Access Compliance Report

Public Rights-of-Way

Intersection ID: 23166	Main Street: LAUREL_POINTE_WY	Cross Street: LAUREL_VIEW_DR	Location: SE
ADA ID: 8641174EEC2A	Ramp Type: Perp	Initial Pass/Fail: Fail	Overall Compliance: No
		Severity Score: 12.5

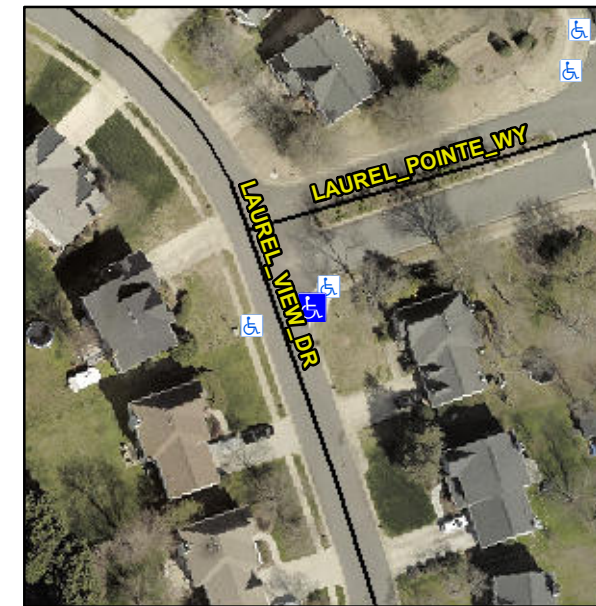
Not Found, R304.2.2

Compliance	Description	Data	Compliance	Description	Data
N/A	Ramp Length (in)	103.0	No	Ramp Slope (%)	10.2
Yes	Ramp Width (in)	48.0	Yes	Ramp XSlope (%)	0.2
N/A	Flare Type LT	N/A	N/A	Flare Type RT	N/A
N/A	Flare Slope LT (%)	N/A	N/A	Flare Slope RT (%)	N/A
N/A	Flare Traversable LT?	N/A	N/A	Flare Traversable RT?	N/A
N/A	Landing Length (in)	N/A	N/A	DWS Provided?	N/A
N/A	Landing Width (in)	N/A	N/A	DWS Contrast?	N/A
N/A	Landing Slope (%)	N/A	N/A	DWS Length (in)	N/A
N/A	Landing X Slope (%)	N/A	N/A	DWS Full Width?	N/A
N/A	Landing Curb? (Y/N)	N/A	N/A	DWS Offset (in)	N/A
N/A	Shared Landing?	N/A			
N/A	Gutter Ponding?	N/A	N/A	Gutter Slope (%)	N/A
N/A	Gutter Lip Ht (in)	N/A	N/A	Gutter X Slope (%)	N/A
N/A	Painted X Walk1?	No	N/A	Painted X Walk2?	N/A
	X Walk 1 Direction	To W		X Walk 2 Direction	N/A
N/A	X Walk 1 Width (in)	N/A	N/A	X Walk 2 Width (in)	N/A
	X Walk 1 Slope (%)	1.6		X Walk 2 Slope (%)	N/A
	X Walk 1 X Slope (%)	1.5		X Walk 2 X Slope (%)	N/A

Remove & Replace Entire Ramp.
